Ref.	2HKI---	Name	Gelaste klemconsole [2HKI200]	
Drawn	colpaest			
Date	1/06/1998			
Material:	Tolerance:	Standard:	I.S.O. SYMBOL	
1.0332 (DD11 hot dip)	1/2

Scale:	1 : 2		Adapt drawing exclusively with CAD	
DRAWING NUMBER				
44144	FORM		P. 2	
	A4		2 P.

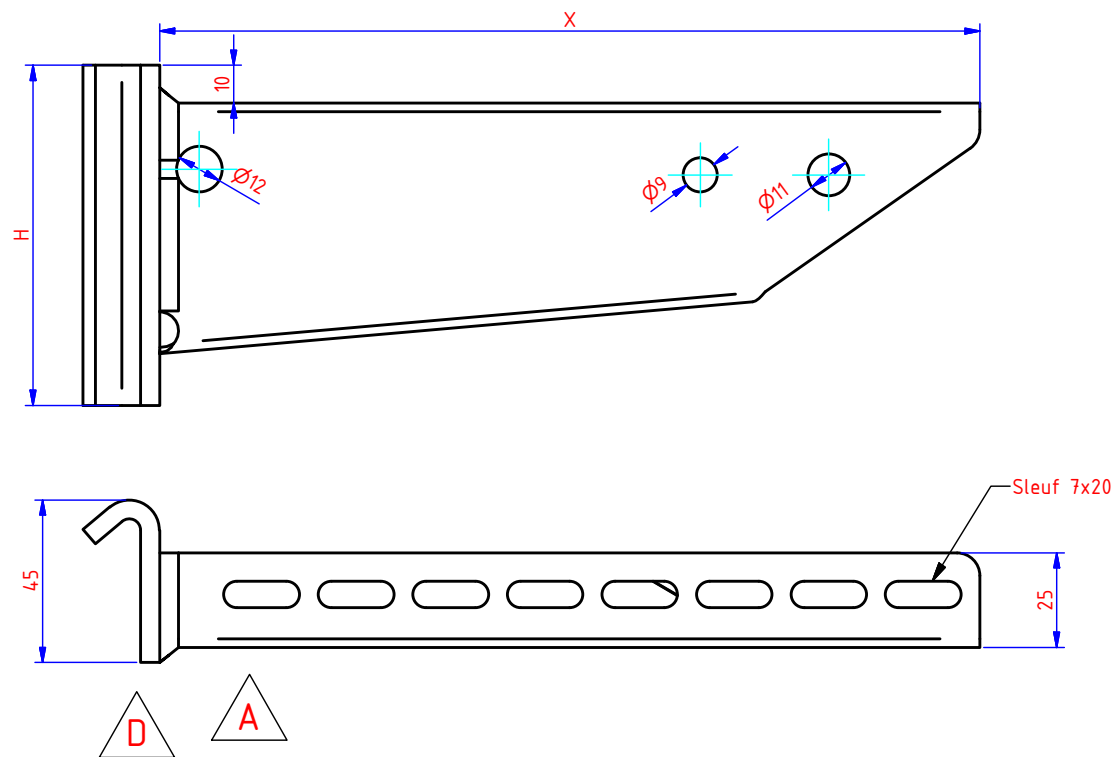
D	console verschoven - was 10 (PWF HKI--- 08 10 2015)	07/10/2015	LA
C	1 gat BSKLEM vergroten van Ø9mm naar Ø11mm. (zie WF HDWK400 - 19 06 2014)	20/06/2014	PN
B	Doorlopend gatenpatroon voor 800 en 1000 (zie WF WK 1000 22 jun 2012)	22/06/2012	PN
4	A	Maat 8+/-1mm ->10+/-1.5mm	26/11/1998
Number	Edition	Description of the modification	Date By
